No Laporte Gravel Corp's Objections to Loveland Ready Mix's Section 112 Permit Application

Knox Pit Application
Laporte, Colorado

No Laporte Gravel Corp's Comments

Threatened Structures < 200'

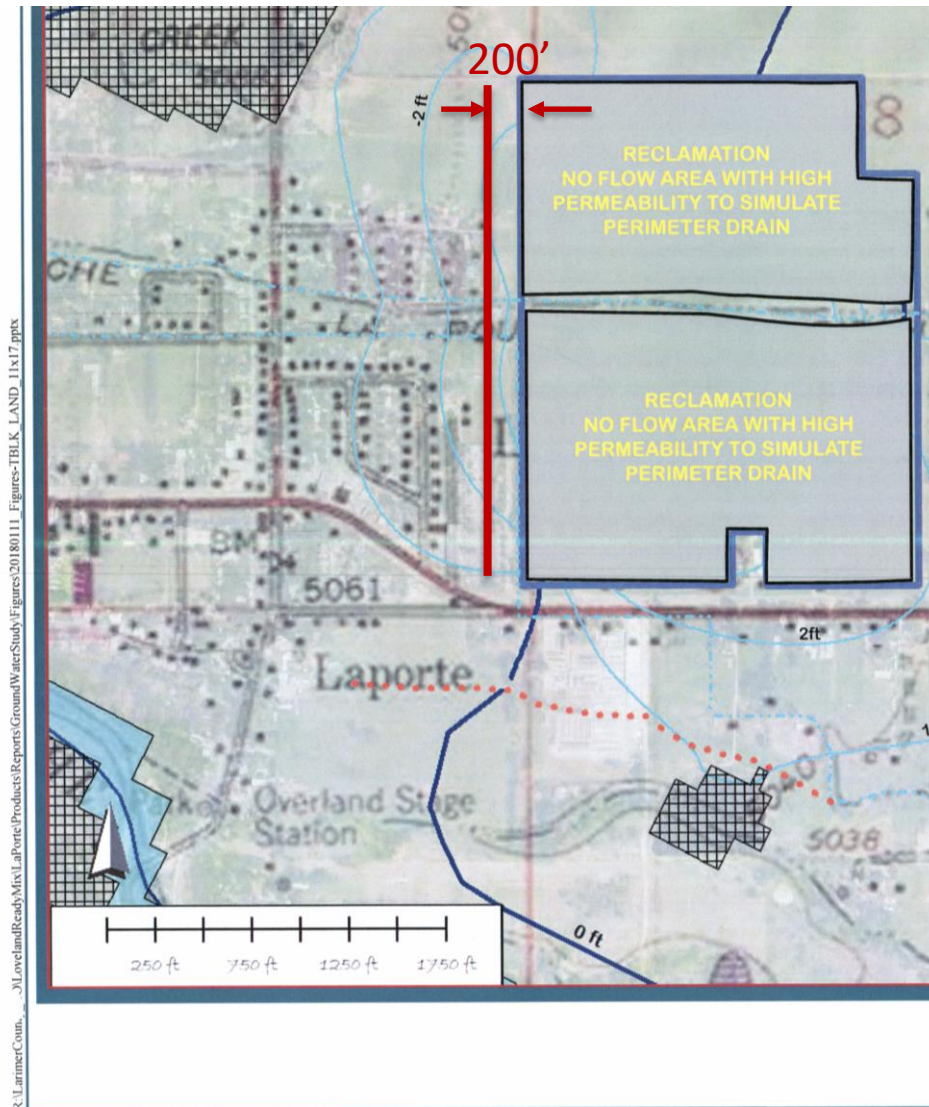
- LRM has not met the requirements of C.R.S. 34-32.5-115(4)(e) and Regulation 6.4.19.
- These provisions require either a signed structure agreement or an engineering study showing damage will not occur to structures within 200' of the mine site.
- The stability of 2 commercial structures and at least 3 private residential structures are threatened by ground water mounding within 200' of the mine site and they have NOT signed a structure agreement and LRM has NOT produced the required engineering study.
- LRM has not met its burden of proving it has complied with C.R.S. 34-32.5-115(4)(e) and Regulation 6.4.19.

The mining operation will adversely affect the stability of any significant, valuable, and permanent manmade structures located within two hundred feet of the affected land. C.R.S. 34-32.5-115(4)(e) and Regulation 6.4.19.

LRM Pit Design Diagram (red area added to indicate potential excavated Pierre Shale)

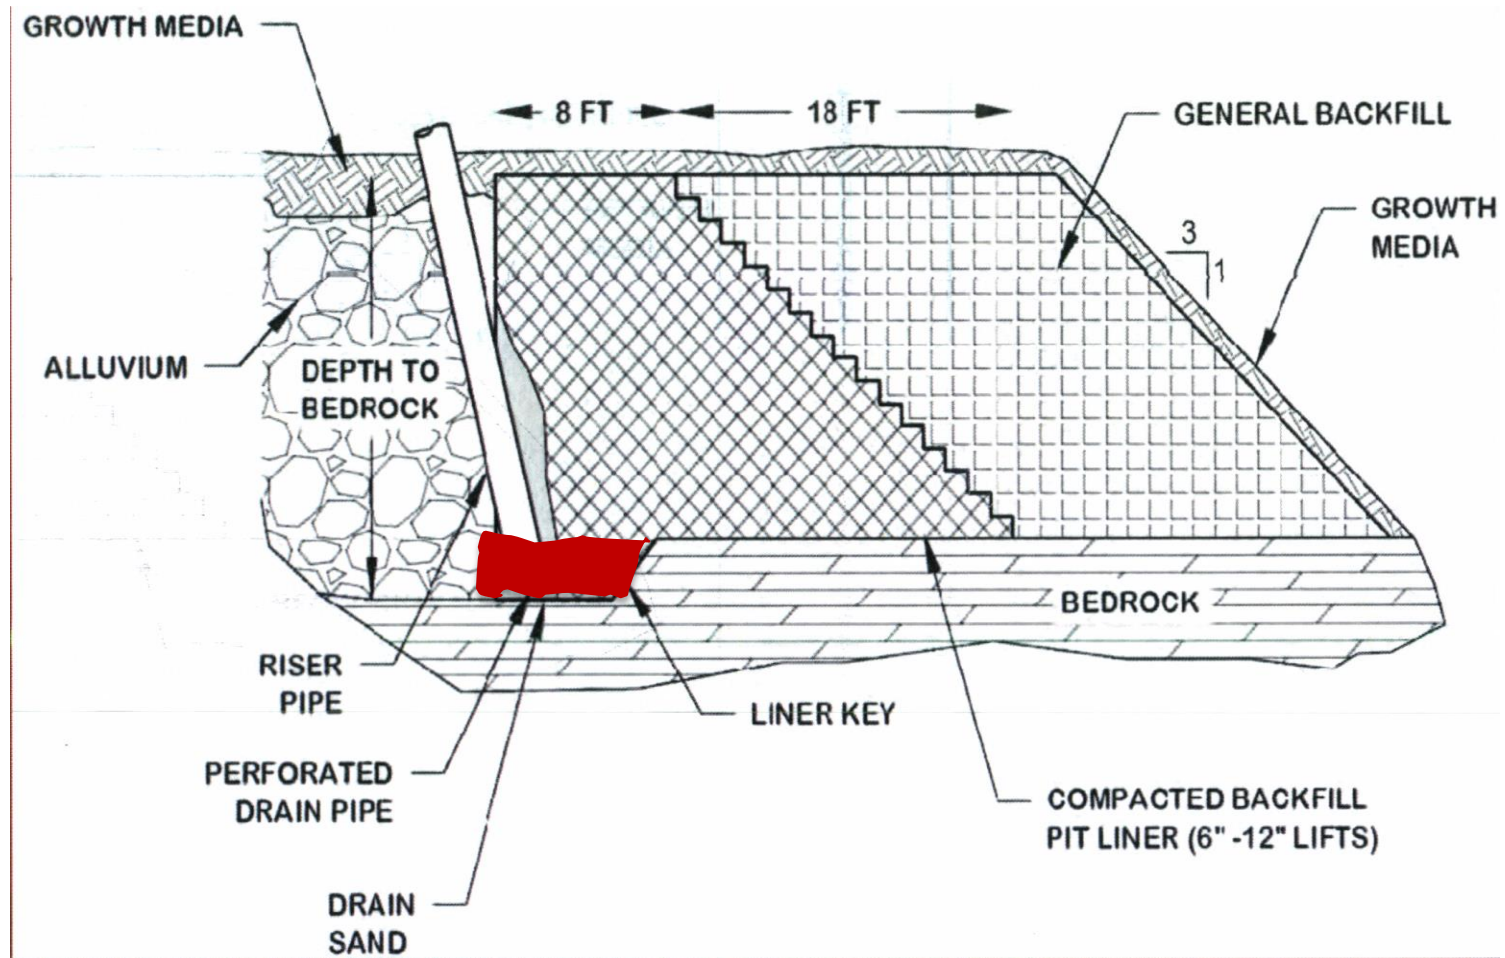
- The mining could cause contamination of groundwater. See Havis Report, “**Potential Water Quality Issues from Cretaceous Pierre Shale**” January 2018.
- Pierre Shale could contribute significant concentrations of arsenic, lead, selenium and uranium to water resources. See Table 3 in Havis Report.
- In response to the Division’s questions in Adequacy Review #3, Comment 39a concerning groundwater contamination. LRM stated, “there are not wide-spread water quality issues associated with these activities” in other gravel pits on the Poudre River that expose Pierre Shale. However, LRM provides little evidence to support this statement.
- LRM failed to provide monitoring data for any pollutant in the shale other than selenium. Measurements at surface of shale and below weathered shale horizon miss the important shale material subject to excavation and erosion.

Excavation of Pierre Shale

Relative Viscosity (right axis, Nr), and Solid and Aqueous Phase Arsenic Concentrations in Suspensions of Pierre Shale Particles

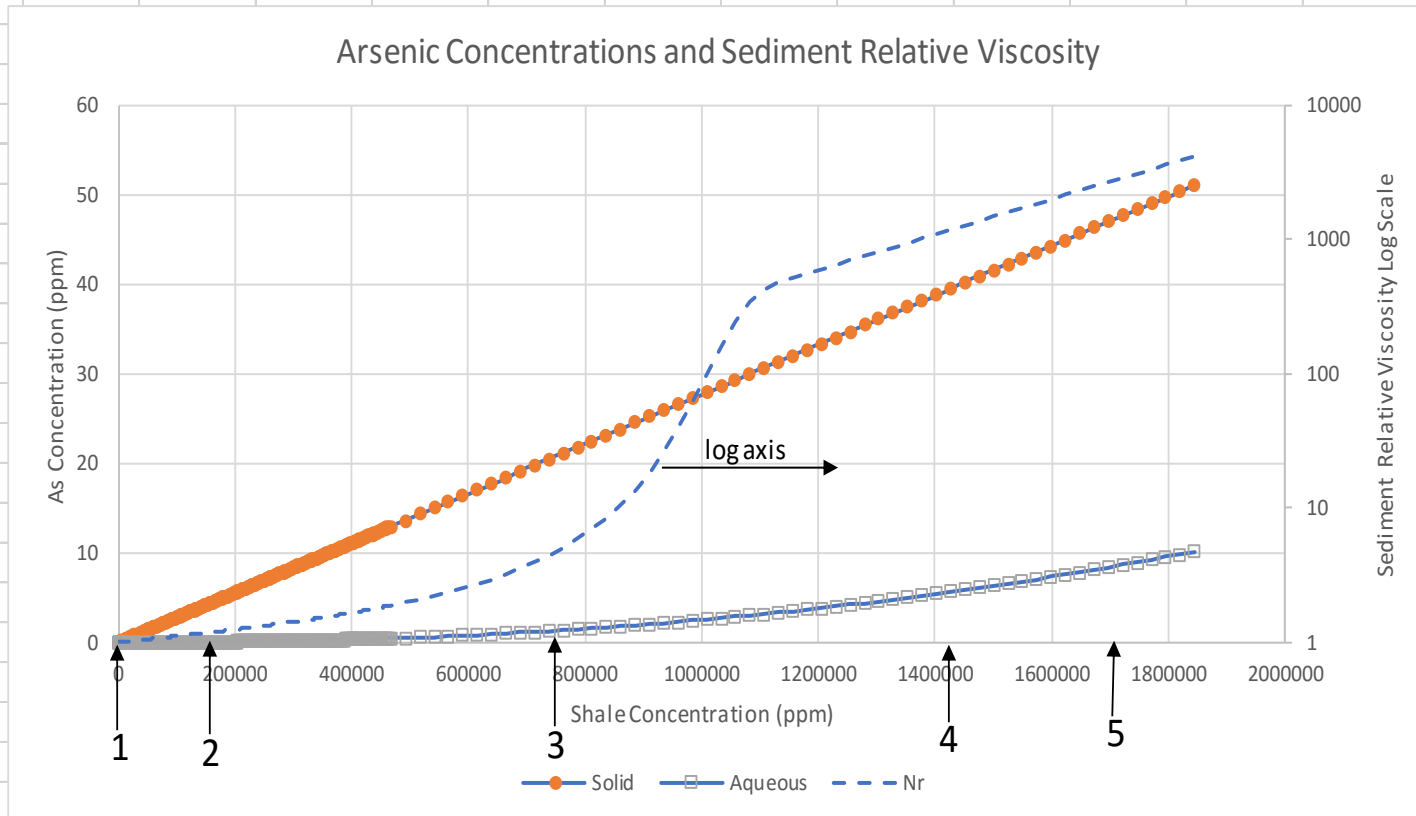
Toxin Concentrations

Potential Toxins - As, Pb, Se, U
